Access Compliance Report Public Rights-of-Way (Curb Ramps)

Intersection ID: 11740 Main Street: BELMONT_AV Cross Street: N_CALDWELL_ST Location: NE

ADA ID: 488CD8289105 Ramp Type: PerpDiag Initial Pass/Fail: Fail Overall Compliance: No Severity Score: 46.25

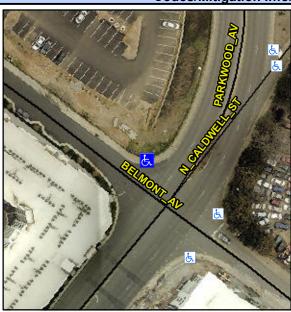
Not Found, R304.5.1, R304.2.2, R304.5.3

Field Measurements/Component Compilance					
Compliance Description Data		Data	Compliance Description		Data
N/A	Ramp Length (in)	60.0	No	Ramp Slope (%)	9.4
No	Ramp Width (in)	44.0	No	Ramp XSlope (%)	9.3
N/A	Flare Type LT	N/A	N/A	Flare Type RT	N/A
N/A	Flare Slope LT (%)	N/A	N/A	Flare Slope RT (%)	N/A
N/A	Flare Traversable LT?	N/A	N/A	Flare Traversable RT?	N/A
N/A	Landing Length (in)	N/A	N/A	DWS Provided?	N/A
N/A	Landing Width (in)	N/A	N/A	DWS Contrast?	N/A
N/A	Landing Slope (%)	N/A	N/A	DWS Length (in)	N/A
N/A	Landing X Slope (%)	N/A	N/A	DWS Full Width?	N/A
N/A	Landing Curb? (Y/N)	N/A	N/A	DWS Offset (in)	N/A
N/A	Shared Landing?	N/A			
N/A	Gutter Ponding?	N/A	N/A	Gutter Slope (%)	N/A
N/A	Gutter Lip Ht (in)	0.5	N/A	Gutter X Slope (%)	N/A
N/A	Painted X Walk1?	No	N/A	Painted X Walk2?	No
	X Walk 1 Direction	To SW		X Walk 2 Direction	To SE
N/A	X Walk 1 Width (in)	N/A	N/A	X Walk 2 Width (in)	N/A
	X Walk 1 Slope (%)	5.4		X Walk 2 Slope (%)	5.7

Remove & Replace Curb Ramp With Two New Directional Ramps or Equivalent.
